# Access Compliance Report

## Public Rights-of-Way

### (Curb Ramps)

Intersection ID: 11597	Main Street: E_20TH_ST	Cross Street: SEIGLE_AV	Location:	N
ADA ID: 196B514AFABA	Ramp Type: Perp	Initial Pass/Fail: Fail	Overall Compliance: No	Severity Score: 25

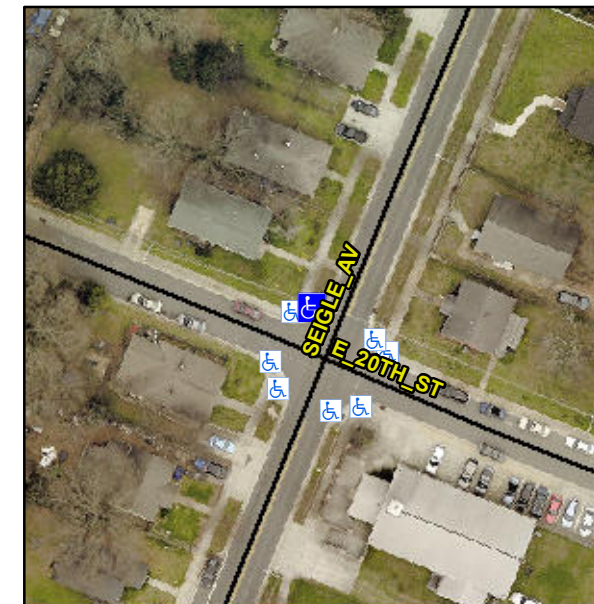
**Not Found, R304.2.2, R304.5.3**

Compliance	Description	Data	Compliance	Description	Data
N/A	Ramp Length (in)	59.5	No	Ramp Slope (%)	8.5
Yes	Ramp Width (in)	48.0	No	Ramp XSlope (%)	6.0
N/A	Flare Type LT	N/A	N/A	Flare Type RT	N/A
N/A	Flare Slope LT (%)	N/A	N/A	Flare Slope RT (%)	N/A
N/A	Flare Traversable LT?	N/A	N/A	Flare Traversable RT?	N/A
N/A	Landing Length (in)	N/A	N/A	DWS Provided?	N/A
N/A	Landing Width (in)	N/A	N/A	DWS Contrast?	N/A
N/A	Landing Slope (%)	N/A	N/A	DWS Length (in)	N/A
N/A	Landing X Slope (%)	N/A	N/A	DWS Full Width?	N/A
N/A	Landing Curb? (Y/N)	N/A	N/A	DWS Offset (in)	N/A
N/A	Shared Landing?	N/A			
N/A	Gutter Ponding?	N/A	N/A	Gutter Slope (%)	N/A
N/A	Gutter Lip Ht (in)	N/A	N/A	Gutter X Slope (%)	N/A
N/A	Painted X Walk1?	No	N/A	Painted X Walk2?	N/A
	X Walk 1 Direction	To SE		X Walk 2 Direction	N/A
N/A	X Walk 1 Width (in)	N/A	N/A	X Walk 2 Width (in)	N/A
	X Walk 1 Slope (%)	0.0		X Walk 2 Slope (%)	N/A
	X Walk 1 X Slope (%)	3.2		X Walk 2 X Slope (%)	N/A

**Remove & Replace Entire Ramp.**
